June 6, 2025

**RE: ARTICLE 5 FEEDBACK LETTER RESPONSE
ESa PROJECT NO. : 24381.00
UNIVERSITY OF WISCONSIN FITCHBURG REHABILITATION HOSPITAL
FITCHBURG, WI**

PLANNING & ZONING COMMENTS

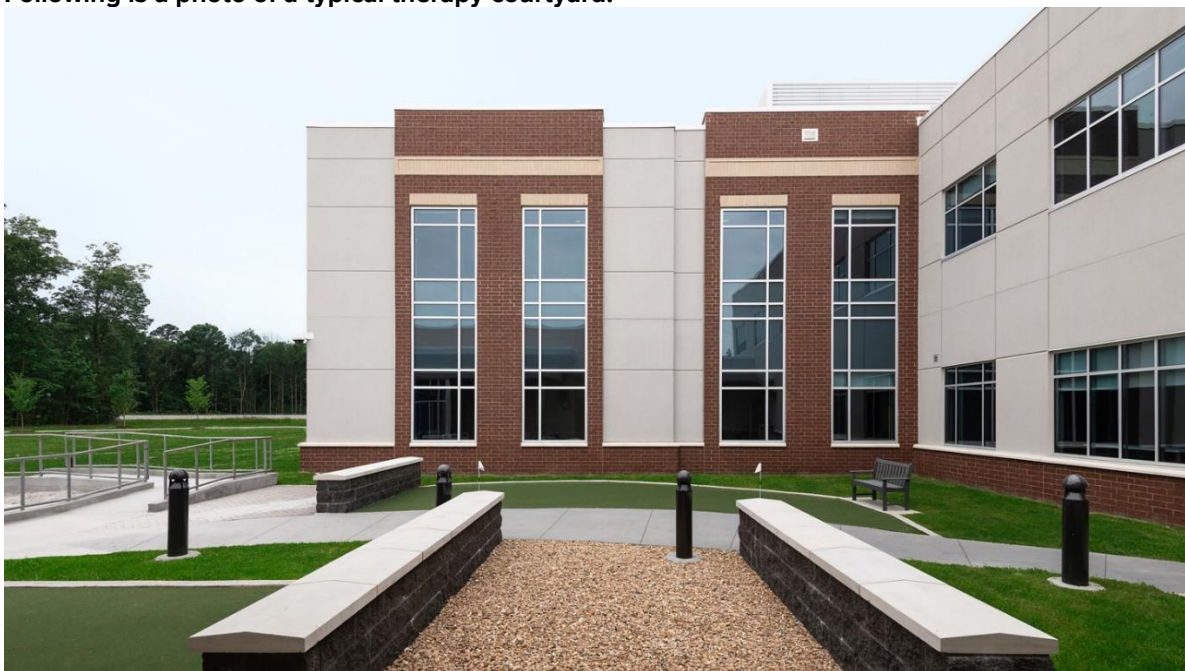
7. What is in the courtyard? It says “see architectural plans” but this is generally unclear on the plans. It appears to be putting, bocce, etc.? Is it natural grass, artificial grass? **Response: The courtyard is an outdoor amenity area targeted for use by the patients and includes terrace areas with seating, a putting green and a bocce ball court, a variety of paved surface, as well as some ramps and stairs to provide opportunities for outdoor therapy. Many of the patients in this facility can benefit from these features, helping them to relearn balance and improve their gait, after a physical injury. This space is also intended for use by the residents after hours for recreation and passive outdoor activity. See sheet A1.00 for coverage calculations – the courtyard areas that are impervious have been included in the coverage calculations.**

Following is a photo of a typical therapy courtyard:

1 EAST ELEVATION
SCALE: 1/8" = 1'-0"

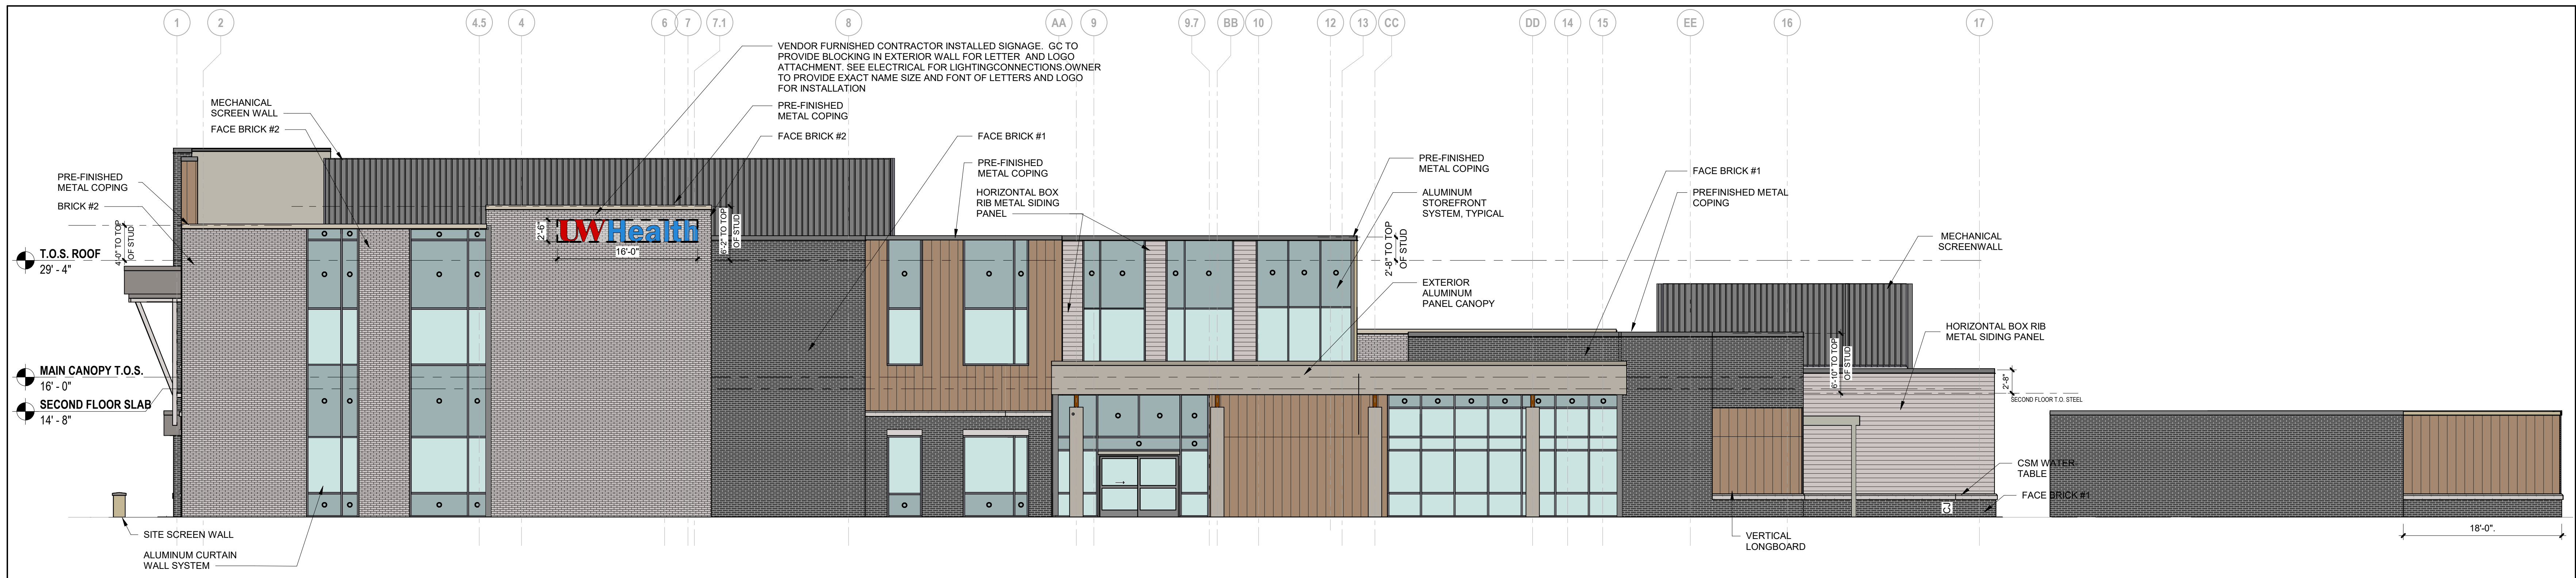
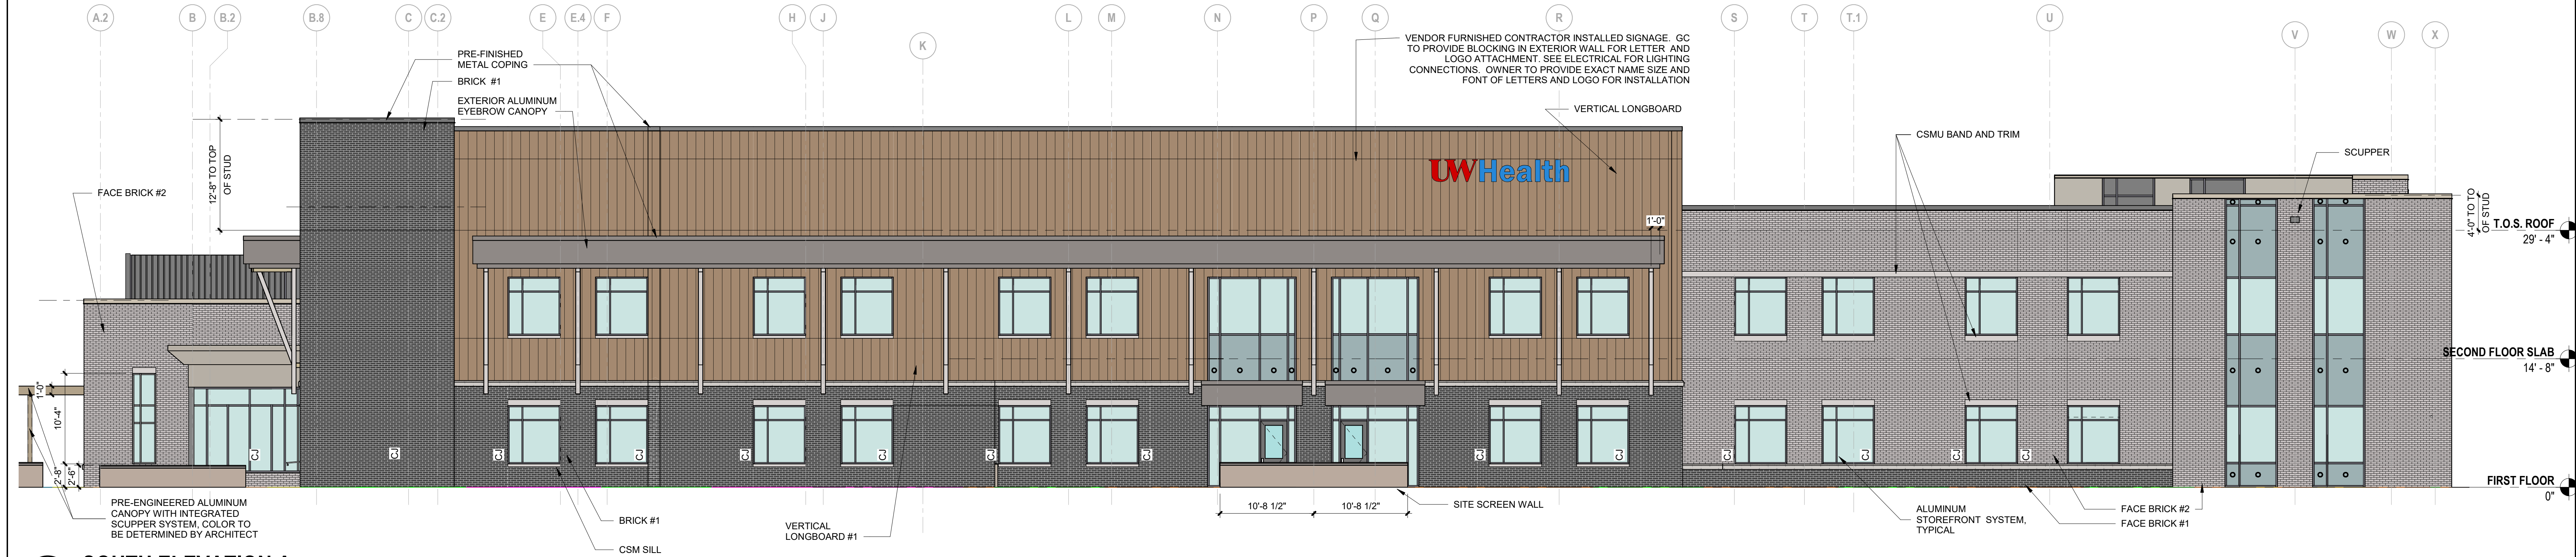
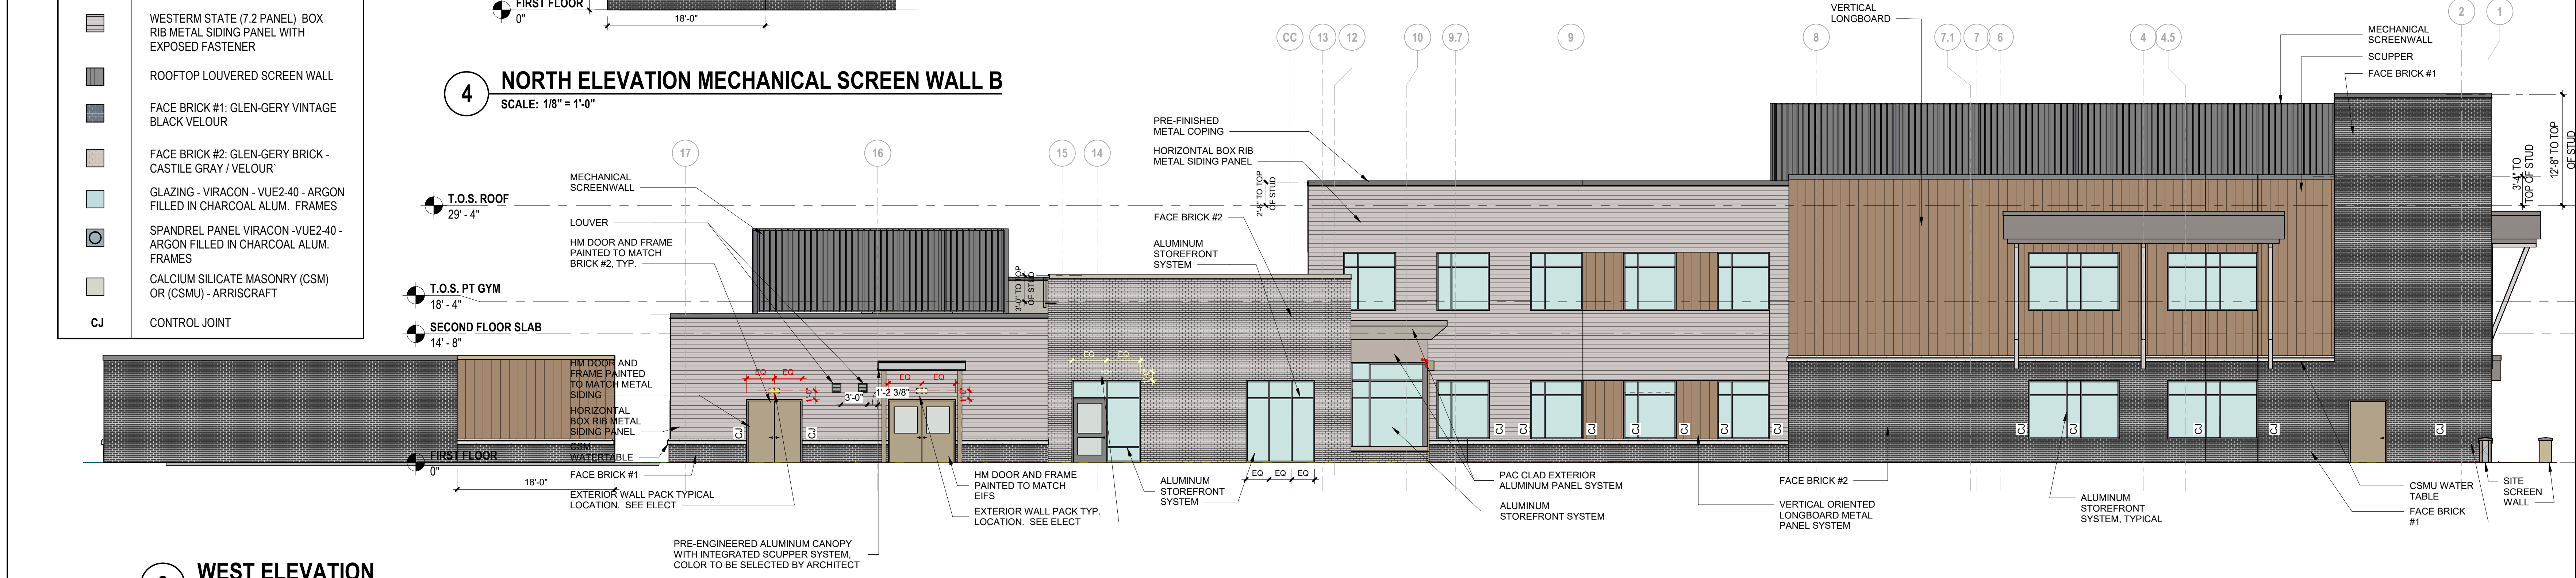
5. The primary façade materials on E. Cheryl should be durable materials, see 5.13.6, at least for the street story façade. Finished metal may be used as accents, but should not be the primary material. There is flexibility in ADR standards, but staff will want to see general consistency. Staff is in support of a design similar to the UW Health facility on E. Washington, Union Corners Clinic, for example. **Response: We looked at the UW Union Corners Facility to better understand the expected design criteria. We have reduced the amount and type of metal panels proposed on the Cheryl facing side of the building. Additionally we have increased the total brick percentage on the first floor elevation. Several other comments are also addressed with the proposed, modified design, as follows:**

6. Please provide more information on this mechanical screen wall. It should not be a metal paneled wall that is very obvious screening. It should match the quality and materials of the rest of the building. **Response: See Details in Item #5 above.**

- a. **We have increased the height of the exterior wall on the Cheryl face to integrate the screen wall for our rooftop mechanical equipment into the primary façade. The material proposed is the "Longboard" metal siding which is a wood look vertical metal siding. We are proposing to**

- provide a return on the 2 ends and would like to keep the metal screen wall on the other 3 facades, which are much less visible from the public way. (Addresses item #6)

- b. The use of the spaces on the primary façade (Cheryl) is predominantly patient rooms. In order to create some additional interest we have enlarged the windows at the location of Day Rooms in the plan. We are proposing a small terrace with a garden wall enclosure at the ground floor which creates the look of an entrance, while still maintaining the required use of all spaces. This will not be a public entrance, but it does create the desired visual we believe to be desired. (See Item #13 and 15)

- c. Modifications have been made to the exterior façade along Cheryl and to a lesser extent along Greenmarket to create a more defined visual base, middle and top. This includes the addition of an eyebrow awning with decorative brackets for a majority of the Cheryl façade, and a more discernable brick water table that varies in height. We elected to leave the southeast corner as previously proposed to allow for a visual break to the horizontality and to provide a different architectural treatment while addressing the corner. On the Greenmarket face we have adjusted the area to the left of the main entrance to have a more discernable base. (See Item #14).
